UNITED STATES PATENT AND TRADEMARK OFFICE

10/750,580

Office Action Summary

DETAILED OFFICE ACTION

Fig. 1a

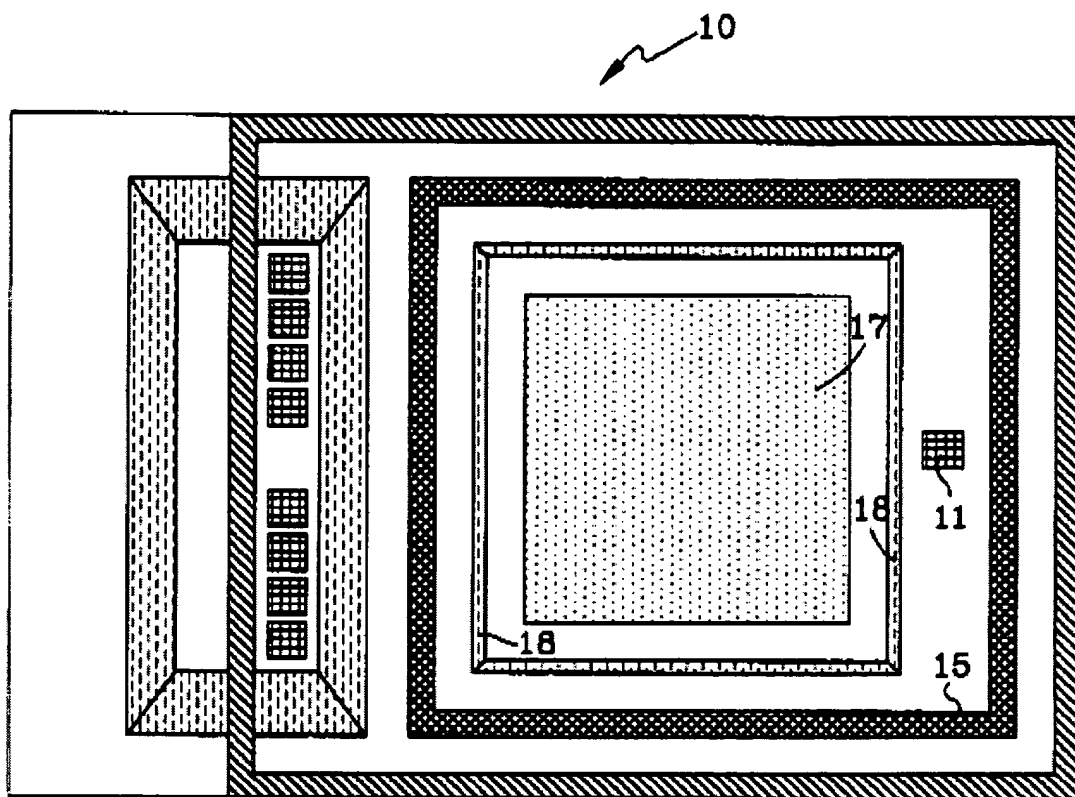
5. Claim 1 is rejected under 35 U.S.C. 102(b) as being anticipated by Wood et al. (U.S. Patent 6,036,872).

With regard to claim 1 wood discloses (in the abstract, in fig 1a, 1b) an integrated package comprising: a first wafer (fig 1b reference 14) having a first surface; a second wafer (fig 1b reference 13) having a first surface bonded at a first perimeter (fig 1a reference 15) to the first surface of the first wafer; and a recess formed (fig 1b reference 18) in the first surface of the first wafer in a second perimeter (fig 1a, reference 17) situated within the first perimeter for a window situated within the second perimeter.

Fig. 1b

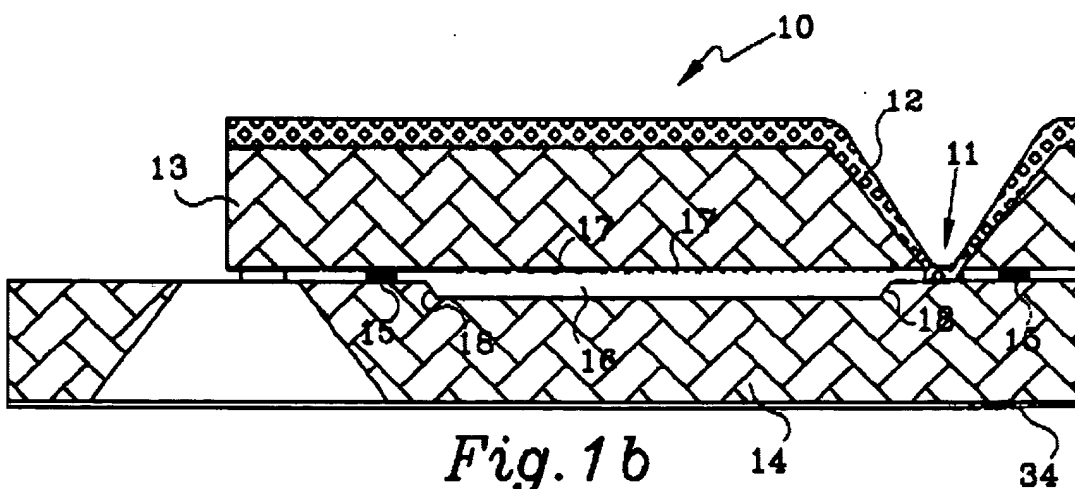
With regard to claim 4, Wood discloses a seal (fig 1b reference 15 ,column 2 lines 14-15) between the first and the second wafer. The rational why claim 4 is obvious over Wood et al in view of Higashi and in further view of Banish et al, has been set forth above.
